# City of Santa Barbara California

## STAFF HEARING OFFICER STAFF REPORT

**REPORT DATE:** July 31, 2014  
**AGENDA DATE:** August 6, 2014  
**PROJECT ADDRESS:** 1117 Las Alturas (MST2014-00223)  
**TO:** Bettie Weiss, City Planner, Staff Hearing Officer  
**FROM:** Planning Division, (805) 564-5470  
 Danny Kato, Senior Planner *[Signature]*  
 Michelle Bedard, Assistant Planner *[Signature]*

# POOL EXHIBIT

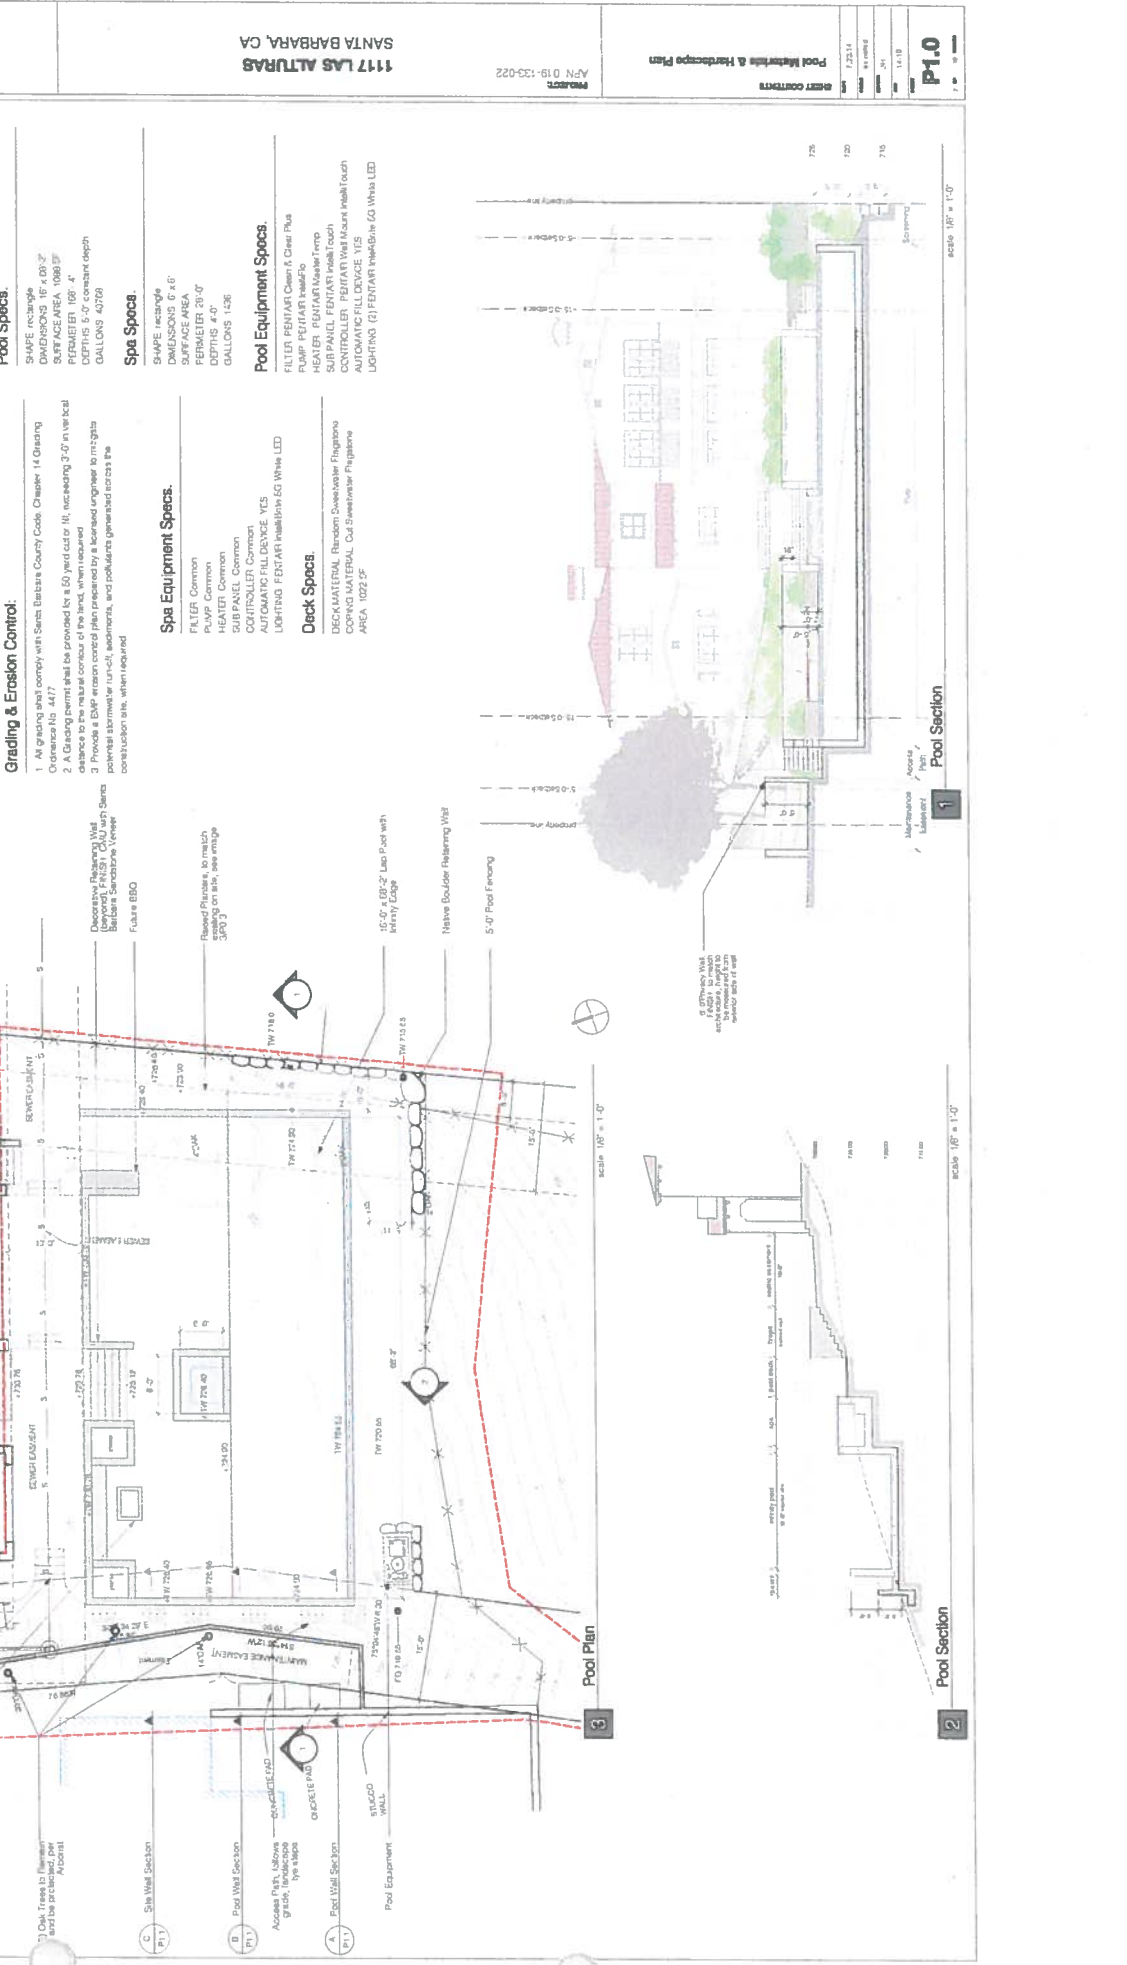
The proposal involves the construction of a new above-ground swimming pool, located on a project site within the Hillside Design District and with an average slope of 49 percent. The design of the proposed pool is located in an east-west configuration across the parcel. Given the existing site topography, the proposed design results in an exposed structure greater than 10-inches in height within the required 15-foot interior setback at the east side of the pool (SBMC §28.15.060).

The proposed pool is to be located 10-feet 9-inches from the westerly property line, which is within the required 15-foot interior setback as well; however, because of the proposed pool configuration and the existing site topography, at this location the proposed pool will be less than 10-inches in height, and therefore complies with the setback requirements.

The site improvements, as proposed, include a new privacy wall (ranging from 7'4" to 8'0" in height) and a new patio wall at the pool deck that steps up in approximately 2-foot increments. The privacy wall is proposed to be constructed 5-feet from the property line to the west to observe the existing maintenance easement. An approximately 20 linear foot portion of these walls do not meet the minimum 5-foot separation requirement and therefore the height is measured as one combined height (measured from the lowest point of the lowest such wall to the highest point of the other wall). The resulting cumulative wall height exceeds 8-feet in

height. The applicant is requesting a minor exception to allow site walls to exceed 8-feet in height when located within the required 15-foot interior setback (SBMC 28.87.170). A portion of the proposed privacy wall is located in close proximity to the existing oak trees and is proposed to be cantilevered above the critical root zone of the existing oak trees. A condition has been added that the proposed privacy wall will be constructed per arborist recommendations in order to confirm the existing oak trees will be protected in place.

Said approval is subject to the condition that the proposed privacy wall (located along the westerly property line) will be constructed per arborist recommendations to ensure the three existing oak trees will be protected in place.

## Legend

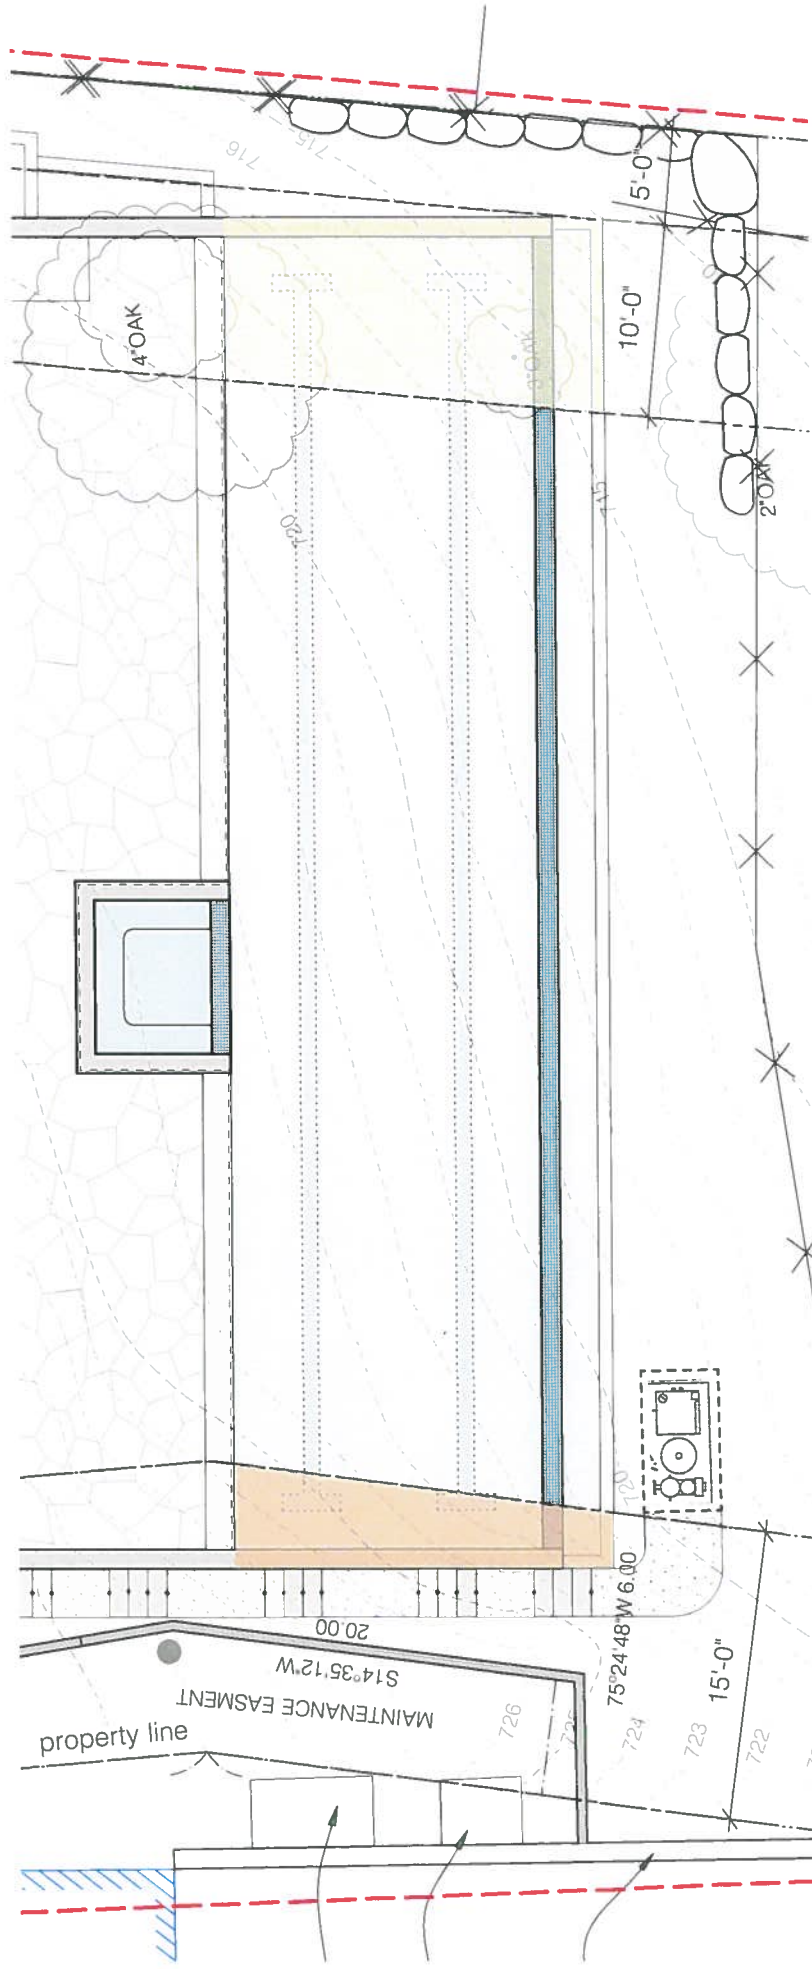
symbol	description	area
	Area of Pool within Setback greater than 10" from Native Grade	180 SF
	Area of Pool within Setback less than 10" from Native Grade within Setback	81 SF

*Note: 55% of pool within 15'-0" of property line is greater than 10" from Native Grade*

An exhibit illustrating the areas of the pool/structure that are in question has been included for your review in consideration of this modification. Should you have any additional conditions, please do not hesitate to give me a call.
